# 802.3dj D3.0

## Comment Resolution

### Optical Topics

Tom Issenhuth (Huawei), Optical Track Lead Editor  
Matt Brown (Qualcomm), 802.3dj Chief Editor  
Guangcan Mi (Huawei), Optical Track Editor  
Roberto Rodes (Coherent), Optical Track Editor

Figure 180-10—TDECQ reference equalizer functional model

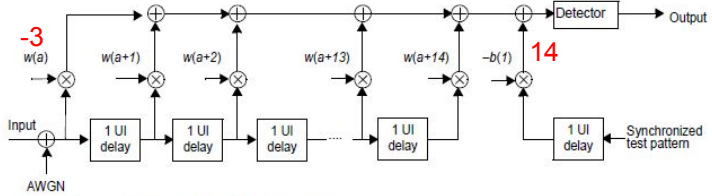
#465 Fix the main tap position e.g. at position 4, and add up to 3 more FFE taps as necessary to preserve the FFE's effectiveness. Remove the variable a in Figure 180-10  
 □ change to the tap weight too?

No update needed for this comment

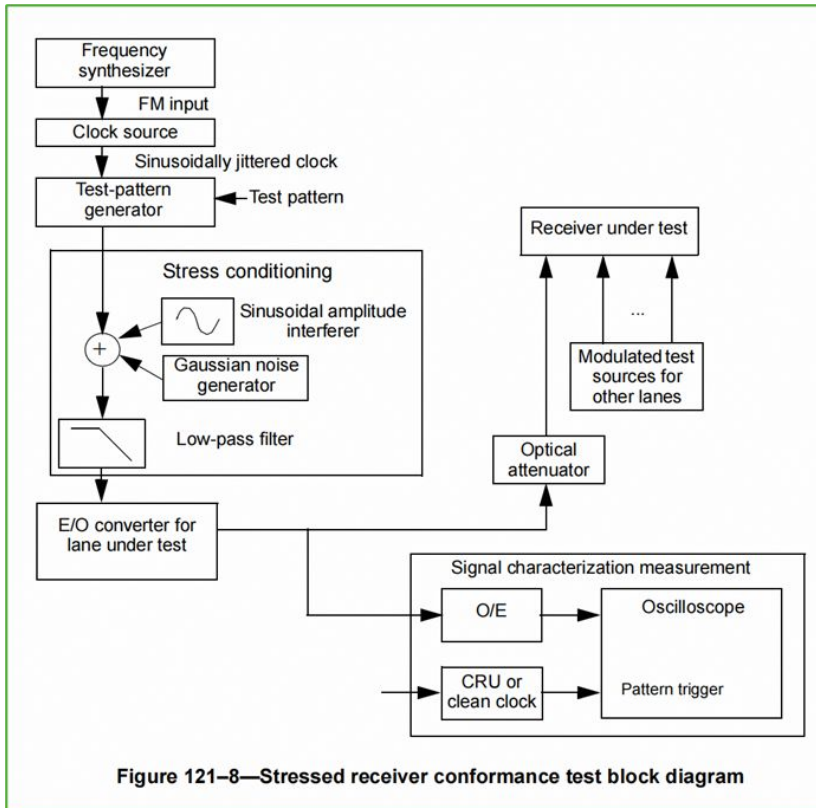
The frequency of the sinusoidal amplitude interferer in the stressed Rx test is not specified. If its period is significantly longer than a FEC code-word it will cause significant degradation in BLER for the same BER and TECQ due to it significantly increasing the probability of correlated errors

Add an additional exception at line 42. "- The frequency of the sinusoidal interferer is greater than 200MHz. Add the same exception to 181.9.16, 182.9.16 and 183.9.16

- The frequency of the sinusoidal interferer is greater than 200MHz.

Figure 180-7—Reference receiver block diagram

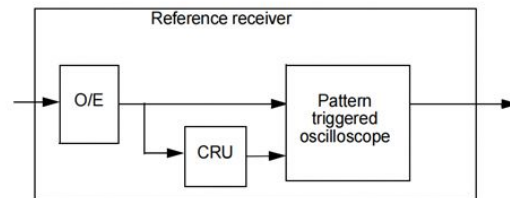
The choice of fourth-order Bessel-Thomson response is a historical accident. Fifth order rolls off a bit steeper at high frequencies, which is more realistic, and has no other significant difference. The better roll-off leads to better measurements. This is also true for measurements where reflections at an instrument's electrical connectors are a concern. This is our chance to make the change, as the industry transitions to a new speed and new test equipment.

Change fourth-order to fifth-order throughout the draft.

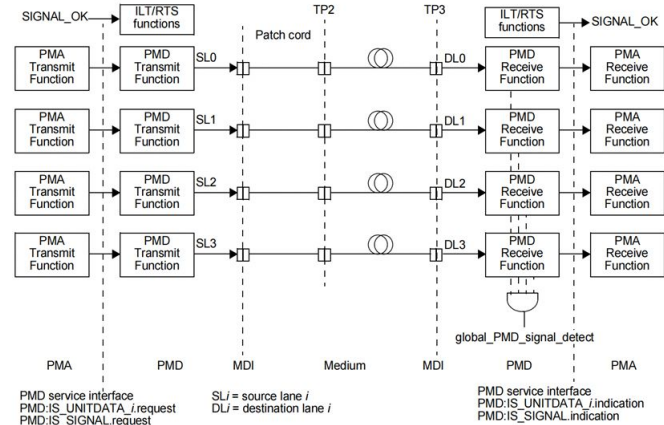
Sometimes this diagram is taken too literally leading to a belief that the 2 to 5 m patch cord and TP2 are part of a service link. They are not; optical cabling may include a variety of connectors (not the type used on test equipment), patch panels, and maybe optical switches, the length of any first patch cord is not regulated, and there may be no accessible TP2.

Either: remove TP2 from the medium, and show the patch cord and TP2 (connected to test equipment) as an alternate;  
 or: at line 2 normative text, add: While TP2 and the patch cord for transmitter measurements and tests are shown in Figure 180-2, they are not part of the medium. The transmit MDI is connected to the medium for use, or to the patch cord and TP2 transmitter measurements and tests.

Implement the second option: at line 2 normative text, add: While TP2 and the patch cord for transmitter measurements and tests are shown in Figure 180-2, they are not part of the medium. The transmit MDI is connected to the medium for use, or to the patch cord and TP2 for transmitter measurements and tests.  
 Implement with editorial license and over all optical clauses.

While TP2 and the patch cord for transmitter measurements and tests are shown in Figure 180-2, they are not part of the medium. The transmit MDI is connected to the medium for use, or to the patch cord and TP2 for transmitter measurements and tests.

Figure 180–12—Transmitter functional test block diagram

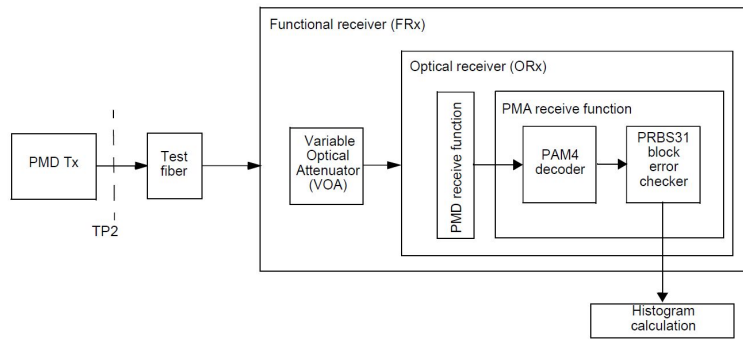
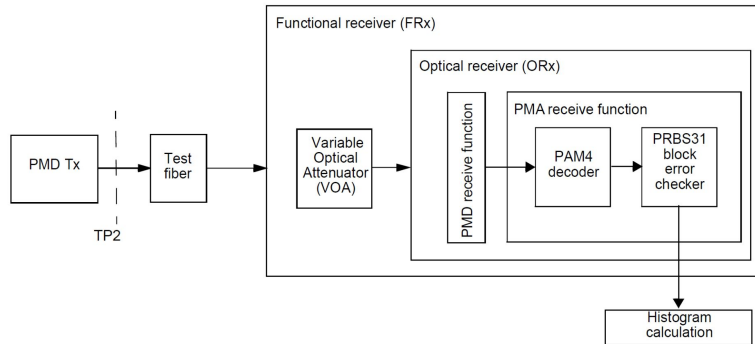
The Transmitter functional symbol error histogram (TFSEH) subclauses should be revised. A supporting presentation with the proposed changes for 180.9.9, 181.9.9, 182.9.9 and 183.9.9 will be provided.

Using "FRx" to mean "functional receiver" is very confusing, since FR is also used to indicate the 2 km CWDM PMD family, and "FRx" or "FRn" are commonly used to indicate a set of FR PHYs.

The transmitter functional test uses a functional receiver (FRx) defined in 180.9.9.1 to measure a transmitter functional symbol error histogram (TFSEH) defined in 180.9.9.2. A block diagram showing the functional receiver is shown in Figure 180–12. The transmitter under test is connected to the functional receiver by a test fiber which meets the requirements in 180.9.6.2. Full compliance with 180.9.6.2 requires the test fiber to provide back reflection with polarization state resulting in the greatest RIN. Other test fibers, including patch cords, may be used for additional tests.

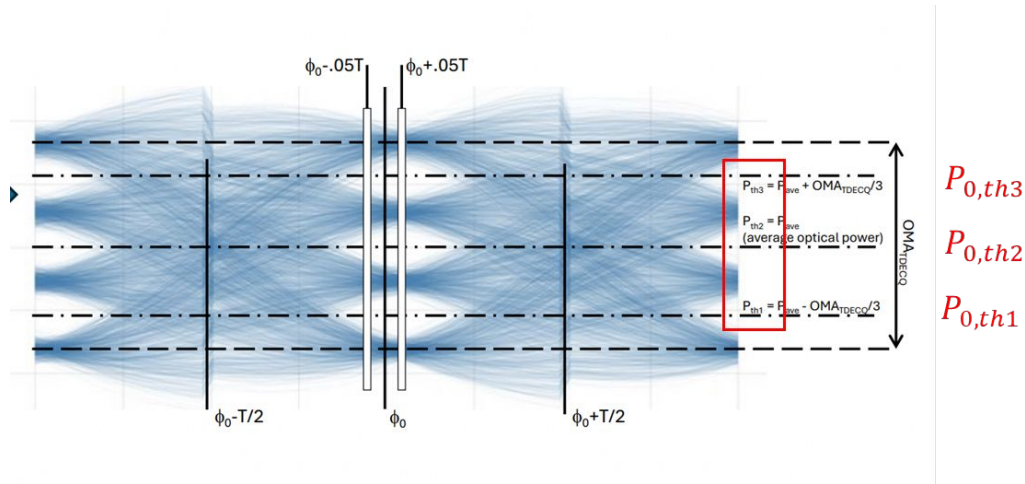
CI 180	SC 180.9.6.4	P481	L33	# 474
Dawe, Piers J G		NVIDIA		
Comment Type	TR	Comment Status	D	TDECQ (OI)
<p>This says that the sub-eye threshold levels P<sub>th1</sub>, P<sub>th2</sub>, and P<sub>th3</sub>, are given by equations 180-1 to 3. Two pages further on, it transpires that this is not the case. There, they are called "nominal values" which isn't very informative, and the symbols P<sub>th1</sub>... are re-used (which one would do in a computer program but it's bad in a document).</p>				
<b>Suggested Remedy</b>				
<p>Change "The sub-eye threshold levels P<sub>th1</sub>, P<sub>th2</sub>, and P<sub>th3</sub>" to "The centers of the three sub-eye threshold ranges, P<sub>0th1</sub>, P<sub>0th2</sub>, and P<sub>0th3</sub>, are ..."</p> <p>Adjust the symbol names in equations 180-1 to 3.</p> <p>Add: "The actual sub-eye thresholds, P<sub>th1</sub>, P<sub>th2</sub>, and P<sub>th3</sub>, are found by the optimization process as described below, or equivalent."</p> <p>Leave P<sub>th1</sub>, P<sub>th2</sub>, and P<sub>th3</sub> as they are in equations 180-5 to 8.</p> <p>On page 483, change "P<sub>th1</sub>, P<sub>th2</sub>, and P<sub>th3</sub> are varied from their nominal values by up to ±1% of OMA<sub>TDECQ</sub> in order to optimize TDECQ."</p> <p>to "P<sub>th1</sub>, P<sub>th2</sub>, and P<sub>th3</sub> are adjusted to optimize TDECQ within ranges +/-1% of OMA<sub>TDECQ</sub> around P<sub>0th1</sub>, P<sub>0th2</sub>, and P<sub>0th3</sub> +/-1%."</p> <p>See another comment for a better +/-%</p>

<b>Proposed Response</b>		<b>Response Status W</b>		
PROPOSED ACCEPT IN PRINCIPLE.				
Implement suggested remedy with editorial license.

$P_{th1}$ ,  $P_{th2}$ , and  $P_{th3}$  are varied from their nominal values by up to ±1% of  $OMA_{TDECQ}$  in order to optimize TDECQ. The same three thresholds are used for both the left and the right histogram.
